# ROOSEVELT ASSEMBLAGE

PROPERTY ADDRESS  
6716 Roosevelt Way NE, Seattle WA

# 8.0 ITEMIZED RESPONSE TO EDG

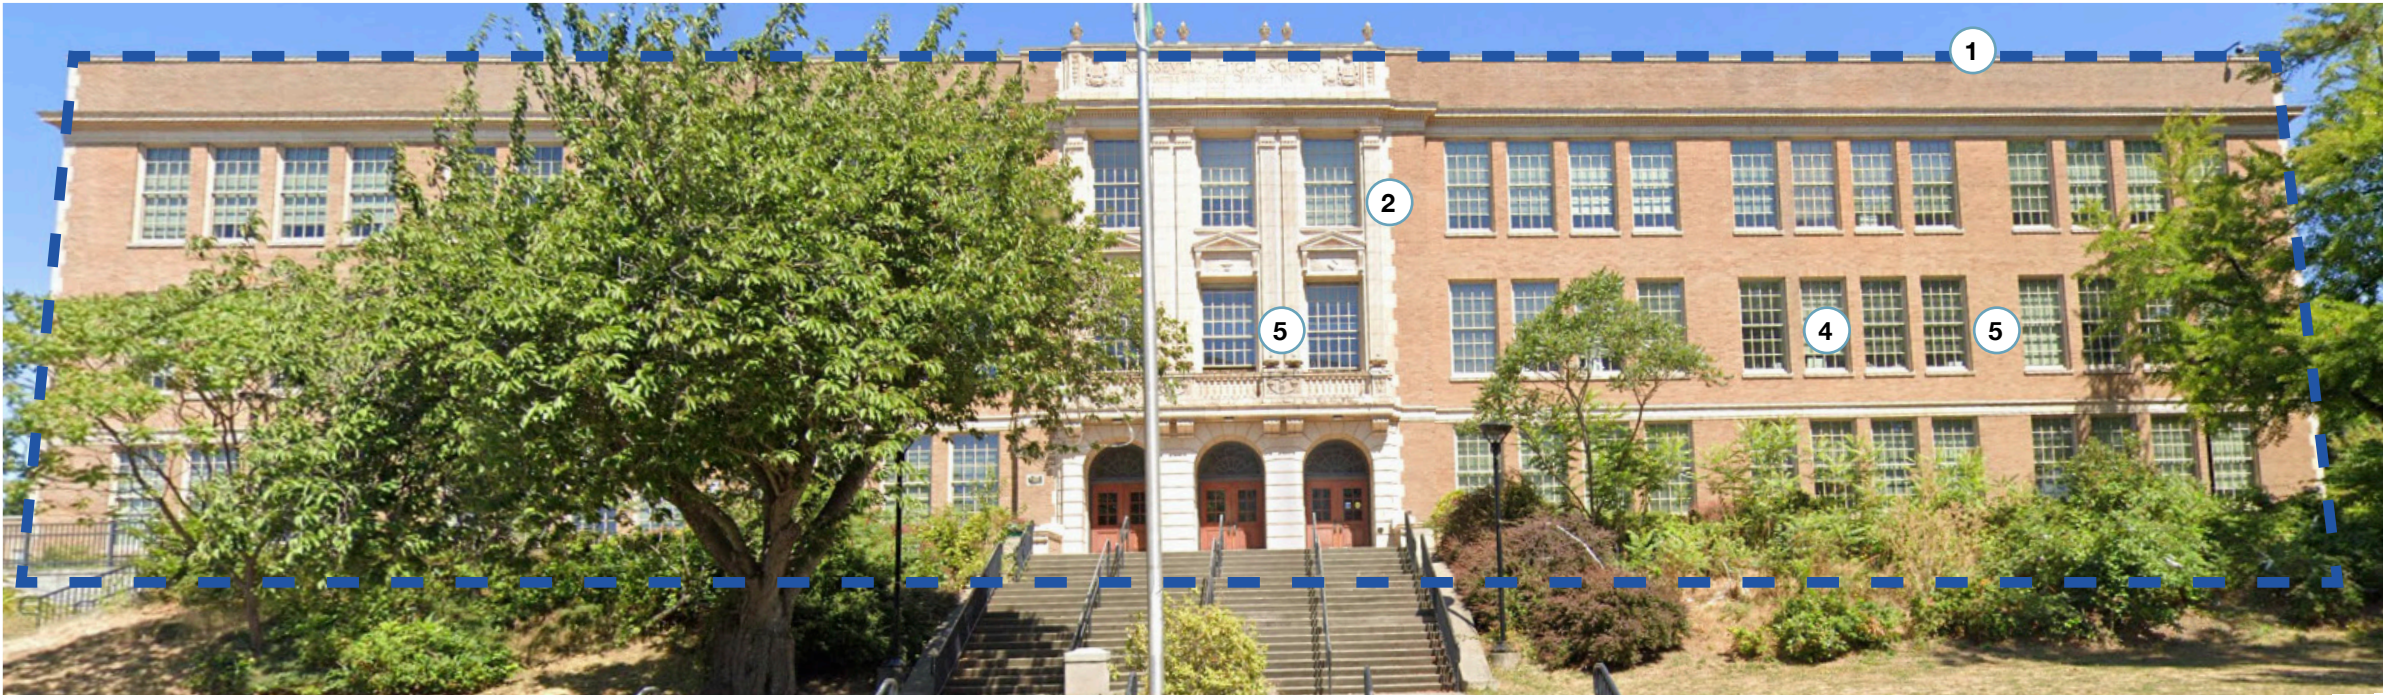
- 1a** a) The Board appreciated the applicant’s overall urban design analysis of the neighborhood but was concerned that there was not enough investigation and study showing how the existing fabric supported the proposed architectural massing concepts. Moving forward, the Board requested more robust analysis of the larger-scaled buildings, such as Roosevelt High School and those shown in orange on page 14 of the EDG packet, and how those structures will inform the development of the architectural massing and modulation. CS2-C-3, CS2-D-1, CS2-III-iv

The design team appreciates the Board’s recognition that scale, pattern, and rhythm are the important aspects of the urban context to consider rather than the mimicry of architectural features found on other buildings. The board noted that Roosevelt High School was a relevant example of a building with long facades that maintain a consistent rhythm of bays and window breakup. We agree: while Roosevelt High School differs from the proposed project in typology, plan, and scale, it is an important public building that offers precedents that can inform the surrounding neighborhood buildings.

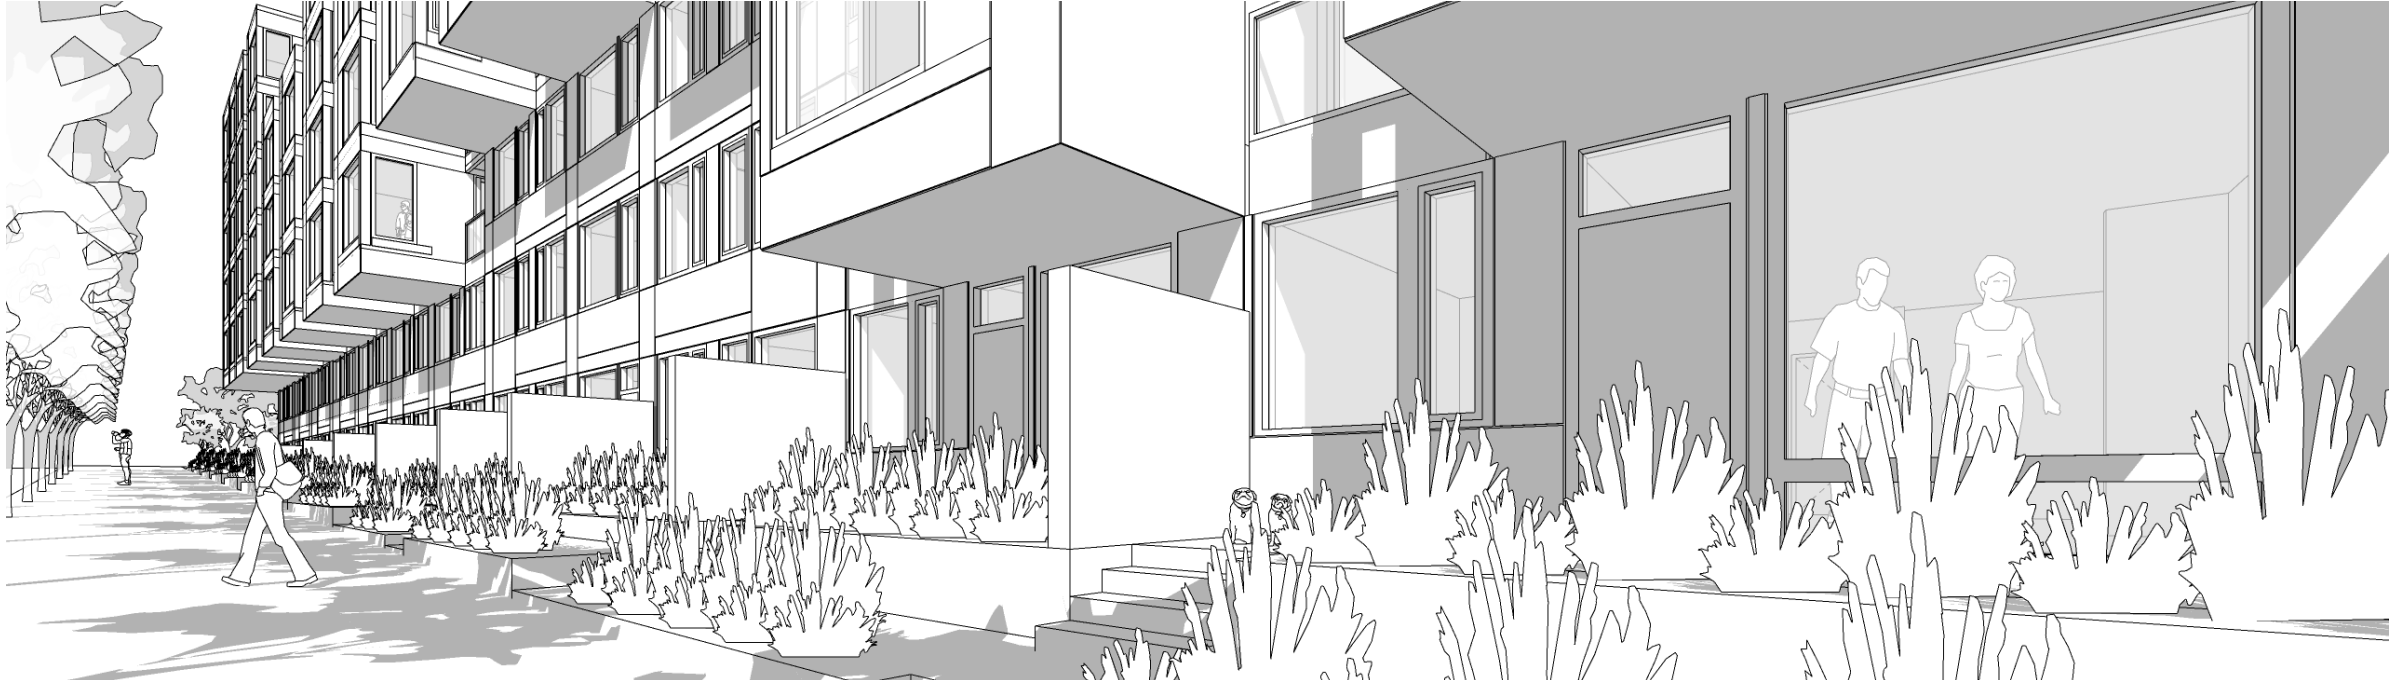
**2c** c) The Board was intrigued by the large undulating massing overhangs created by the 20' wide bays along the north side of the building in that it creates a dynamic carved out space. The Board stressed the importance of a well composed and cohesive design for this space and recommended that the applicant pay particular attention to the materiality of these variously scaled pockets and the treatment of the prominent overhead projections, in conjunction with the landscape design. DC2-B, DC2-C, DC4-A-1, DC2-II-ii

The design employs a limited palette of materials to enhance the massing and modulation of the approved scheme. The light and dark coloration has been studied to not simply reply to the plane changes along the facade length, but to help emphasize the larger scaled modulation without over-emphasizing the repetitive protruding bays. Studies that looked at following the wall plane for color selection yielded an excessively striped facade, while the team feels the preferred scheme is more subtle and effective.

The treatment of the overhead projections is proposed to be white exterior gypsum, to be in plane with the interior ceiling surface and appear as a continuation of it.

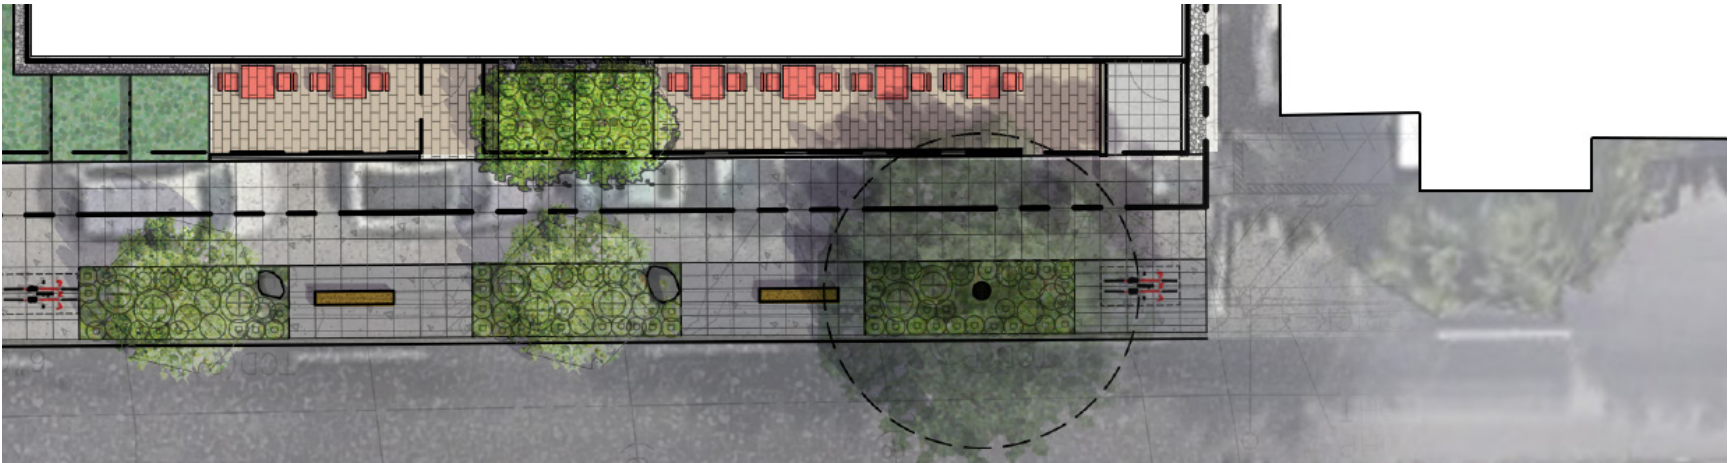
**2c** The variation of heights of the overhangs create interestingly varied qualities of space below them. These spaces will include a variety of plantings along 68th Street, yielding both privacy for units and visual interest for passers-by.

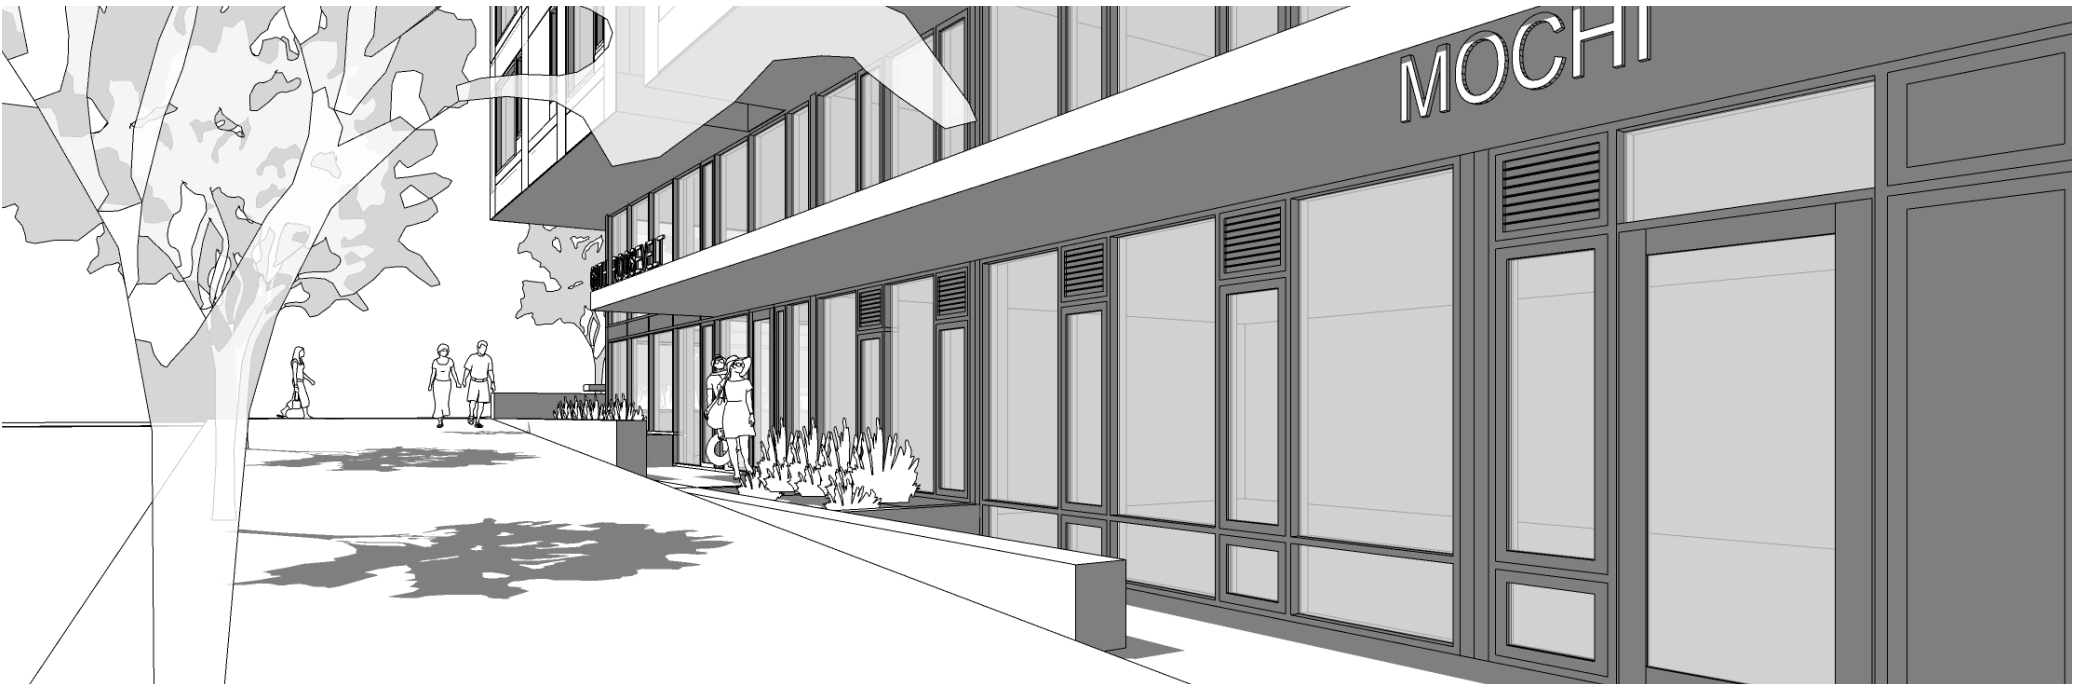
**1b** *b) The Board was concerned with the lack of study of the relationship of the proposed development to the properties to the south and recommended that the applicant provide more information about the adjacent properties, including window studies, and how the existing conditions will impact the development of the architectural massing. The Board placed high importance on understanding the condition at the southwest edge. CS2-D-1, CS2-D-5, DC2-B-2*

The portion of the proposed building that is closest to the southern neighbor, at the southwest edge, is in the NC3P zoning, and faces a Principal Pedestrian Street: Roosevelt Way NE. The existing neighboring development in that zone and along that street consistently holds the street edge, providing a continuous, activated street wall in the pedestrian commercial zone. Per CS2-D-1, we believe setting the proposed building back at the south edge of the NC Zone would yield an unwelcome break in this pedestrian environment, and an unappealing and unsafe, narrow alley to the rear of the property as visible from Roosevelt Way NE.

The landscape plan shows the terraced seating and plantings along Roosevelt Way, appropriately activating the principal pedestrian street of Roosevelt and continuing what is a strong street edge throughout the neighborhood.

NORTHWEST CORNER OF BUILDING TO THE SOUTH; TYPICAL FLOOR PLAN  
SOUTHWEST EDGE OF PROPOSED BUILDING SHOWN IN RED ABOVE

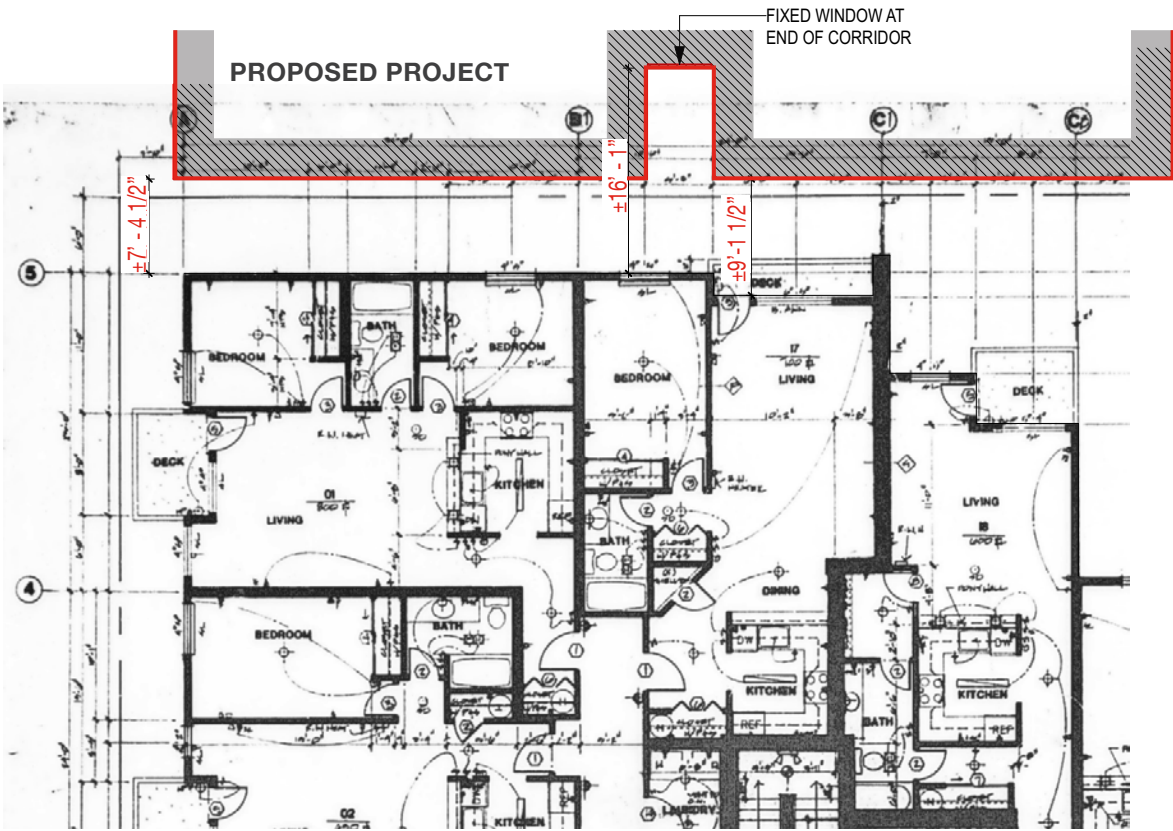
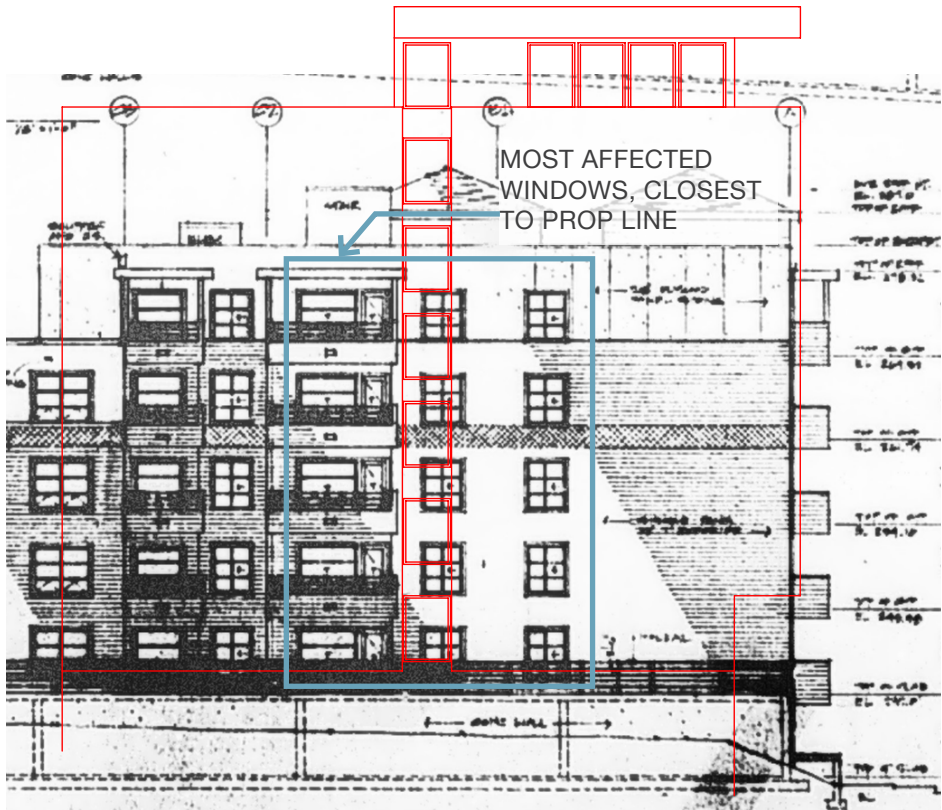
**2e** e) The Board discussed the appropriateness of what appeared to be a blank wall condition proposed along the west end of the building along the southern property line. The Board strongly recommended that the applicant continue to study the location of this wall to determine if it would be more appropriate to provide a setback, and if none is provided, that the material application provide visual interest as it will be visible for an indefinite period. CS2-D-5 CS2-III-iii, DC2-B

See also the response to item 1.b. above. The design team does not feel it is appropriate to set back on the western edge of the southern property line for the primary reason of maintaining the urban, commercial street edge along Roosevelt Way. This portion of the south facade is proposed to have glazing in a recessed slot at the end of the corridor, which will help provide visual interest to this area while not creating privacy issues between units of this building and the adjacent building. The roof terrace and level 7 club room are also visible at the top of this facade and provide glazing and activation, serving as relief from the more opaque wall below. This level is above the adjacent building so will also not negatively impact the privacy of adjacent units. The material used on the opaque portions of the facade will be cleanly and appropriately detailed with understanding of its visibility.

At its closest, the adjacent building to the south is approximately 7'-4 1/2" away from our proposed building. Two stacks of windows, each in a bedroom, are at this closest distance. A small area of living room in one window stack is approximately 9'-1 1/2" away from our proposed wall. To the east of this, the existing building steps another 6 or so feet south.

Our building proposes no unit glazing in this zone, so privacy for the existing building is maintained. However, two stacks of units in the existing building will have reduced daylight access due to our proposed building. Studies of the existing adjacent building in relationship to the proposed building are shown on the following page.
